Site Accessibility Evaluation

Alice Keck Park
219 E Micheltorena St
Santa Barbara, CA 93101
Accessibility Evaluation
Inspection Date: 08/24/2023
Inspectors: Scott Saddlemire

Report Date: 11/03/2023

Finding: 1

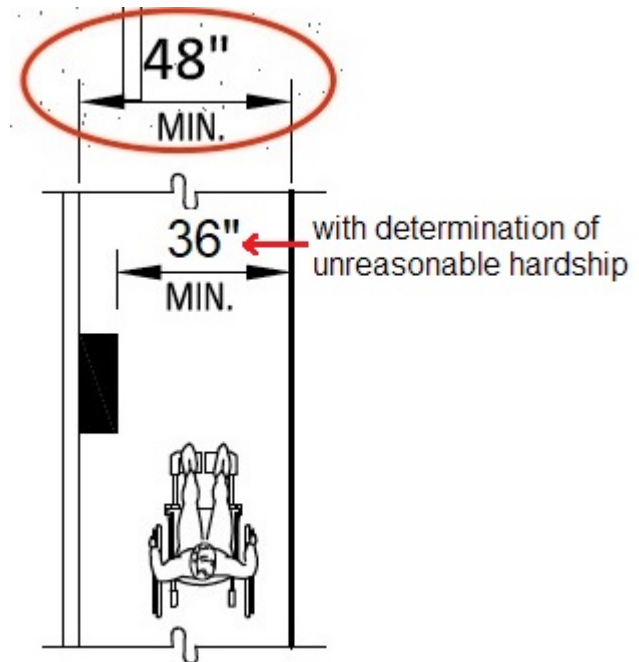
The route of travel does not provide the required minimum width.

The minimum clear width for sidewalks and walks is 48 inches.

When, because of right-of-way restrictions, natural barriers or other existing conditions, the enforcing agency determines that compliance with the 48-inch clear sidewalk width would create an unreasonable hardship, the clear width may be reduced to 36 inches.

See exception 3 in the findings section

Finding: 2

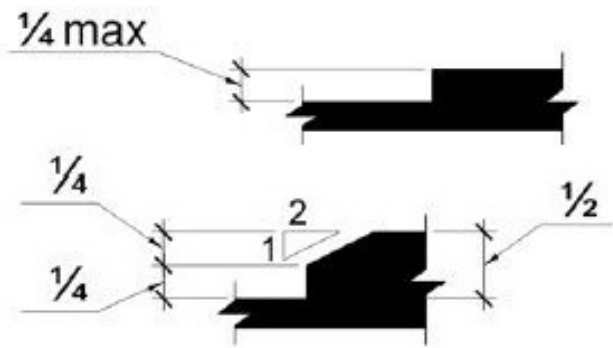
The walkway contains abrupt vertical edges and/or variations over 1/4 inch.

1/4 inch is the maximum vertical rise. Changes in level between 1/4 inch and 1/2 inch must be beveled at 1:2 or less.

Changes in level greater than 1/2 inch must be by way of a ramp.

Finding: 3

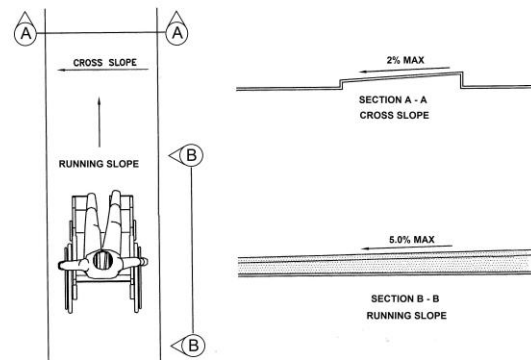
The accessible route has running slopes greater than 5% and has not been constructed as a ramp (i.e. handrails, edge protection, etc.). Cross slopes are greater than 2% across the width of the walk.

When the slope in the direction of travel of any walk exceeds 1 unit vertical in 20 units horizontal (5-percent slope), it must be constructed as a ramp. Surface cross slopes must not exceed 1 unit vertical in 48 units horizontal (2-percent slope).

Finding: 6

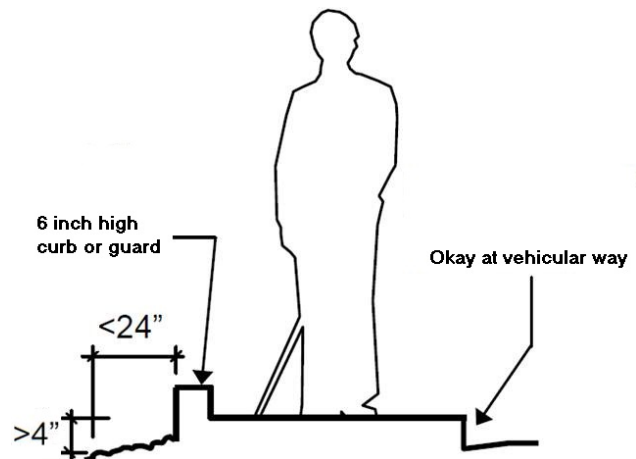
There is an abrupt change in level greater than 4 inches.

Abrupt changes in level exceeding 4 inches in a vertical dimension between walks, sidewalks or other pedestrian ways and adjacent surfaces or features shall be identified by warning curbs at least 6 inches in height above the walk or sidewalk surface.

Finding: 8

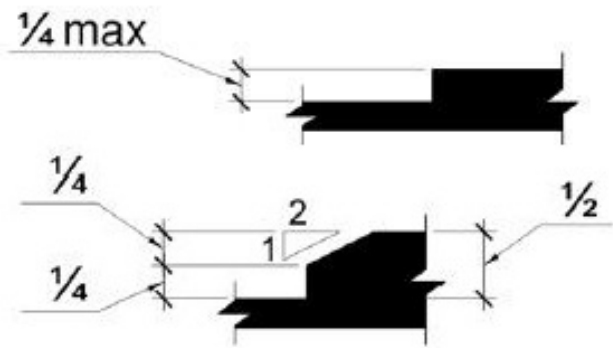
The walkway contains abrupt vertical edges and/or variations over 1/4 inch.

1/4 inch is the maximum vertical rise. Changes in level between 1/4 inch and 1/2 inch must be beveled at 1:2 or less.

Changes in level greater than 1/2 inch must be by way of a ramp.

Finding: 9

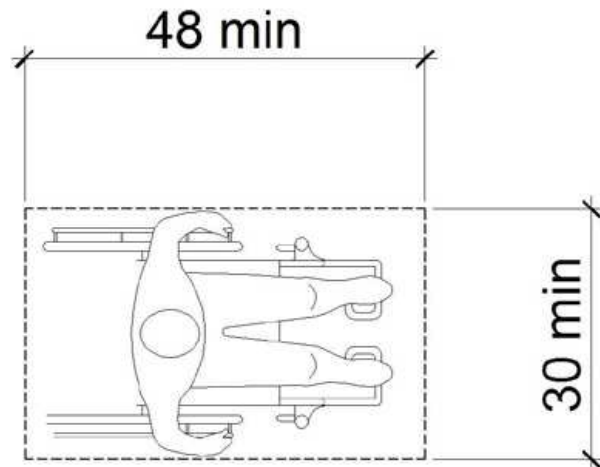
The element is not accessible because there is not adequate clear floor space for an approach.

The clear floor or ground space shall be 30 inches minimum by 48 inches minimum.

Provide level floor space at all of the audio stations

Accessible Routes : Exterior Routes Memorial Park**Finding: 11**

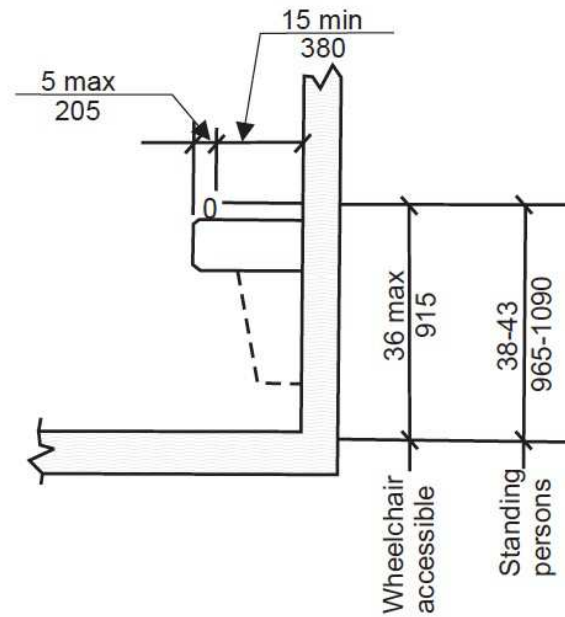
There is no drinking fountain for standing persons.

No fewer than two drinking fountains shall be provided. One drinking fountain shall meet requirements for wheelchair accessibility and one drinking fountain shall meet requirements for standing persons.

Spout outlets of drinking fountains for standing persons shall be 38 inches minimum and 43 inches maximum above the finish floor or ground.

Finding: 12

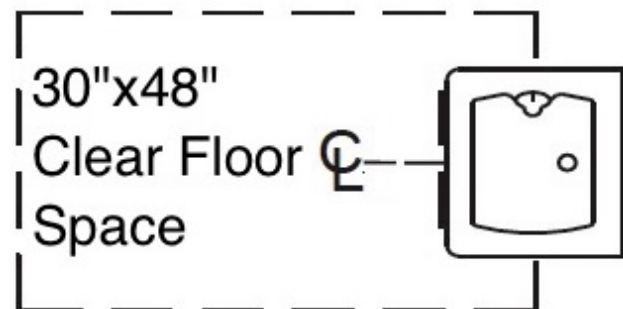
The clear floor space required at accessible drinking fountains is not positioned for a forward approach.

Units shall have a clear floor or ground space positioned for a forward approach and centered on the unit.

plus clear floor space,

Accessible Routes : Exterior Routes Memorial Park**Finding: 15**

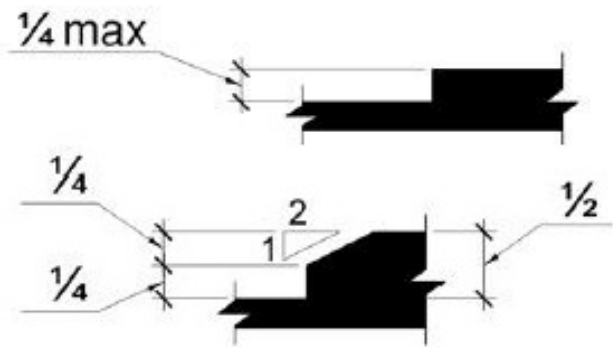
The walkway contains abrupt vertical edges and/or variations over 1/4 inch.

1/4 inch is the maximum vertical rise. Changes in level between 1/4 inch and 1/2 inch must be beveled at 1:2 or less.

Changes in level greater than 1/2 inch must be by way of a ramp.

Finding: 21

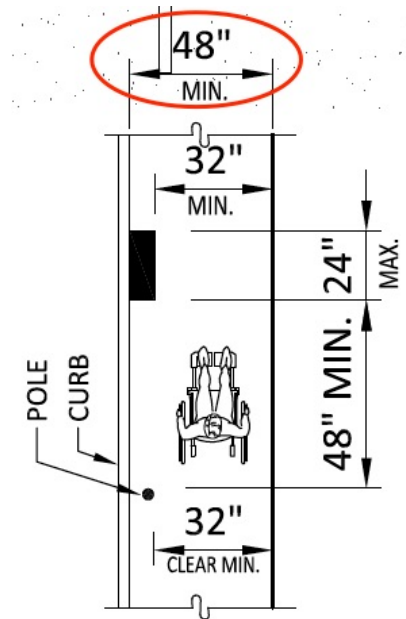
The walking surface is obstructed.

A 48 inch minimum clear walking surface is required.

edge protections and route, not
this finding

Ensure accessible path of travel is not blocked by trash cans, POP displays, ect.

Finding: 22

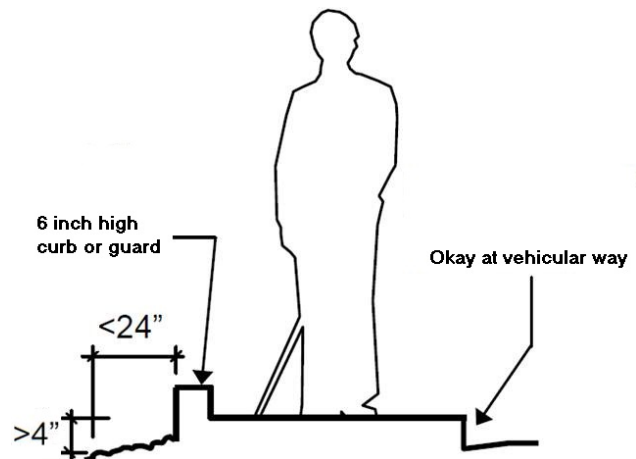
There is an abrupt change in level greater than 4 inches.

Abrupt changes in level exceeding 4 inches in a vertical dimension between walks, sidewalks or other pedestrian ways and adjacent surfaces or features shall be identified by warning curbs at least 6 inches in height above the walk or sidewalk surface.

edge protections and route,

Finding: 27

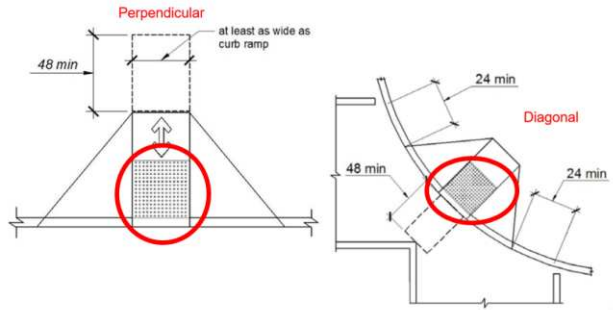
The detectable warning is missing at the curb ramp.

Detectable warnings at curb ramps shall extend 36 inches in the direction of travel. Detectable warnings shall extend the full width of the ramp run less 2 inches maximum on each side, excluding any flared sides. Detectable warnings shall be located so the edge nearest the curb is 6 inches minimum and 8 inches maximum from the line at the face of the curb marking the transition between the curb and the gutter, street or highway.

detectable warning

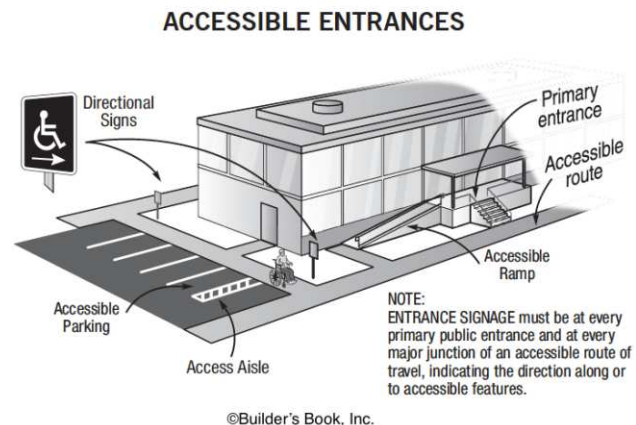
no accessible route

Provide accessible route to the picnic tables

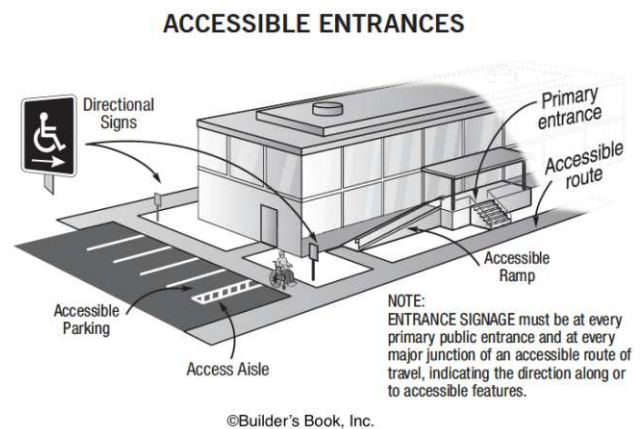
to park bench seating area

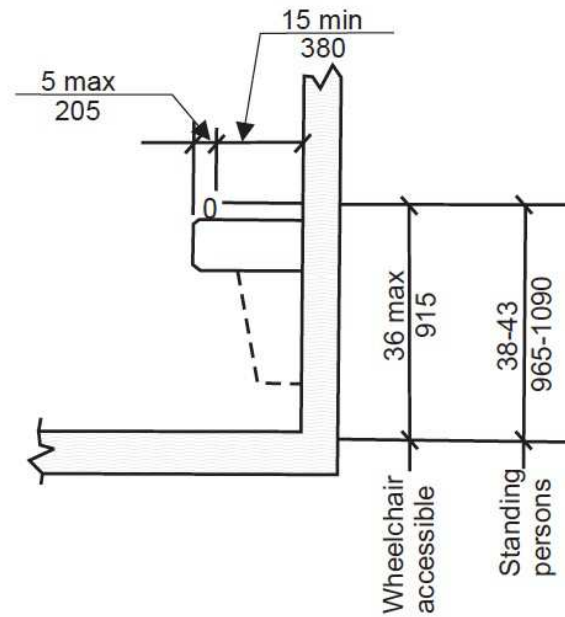
Spout outlets of drinking fountains for standing persons shall be 38 inches (965 mm) minimum and 43 inches (1092 mm) maximum above the finish floor or ground.

2010 ADAS Section: 602.7, 211.2 no standing
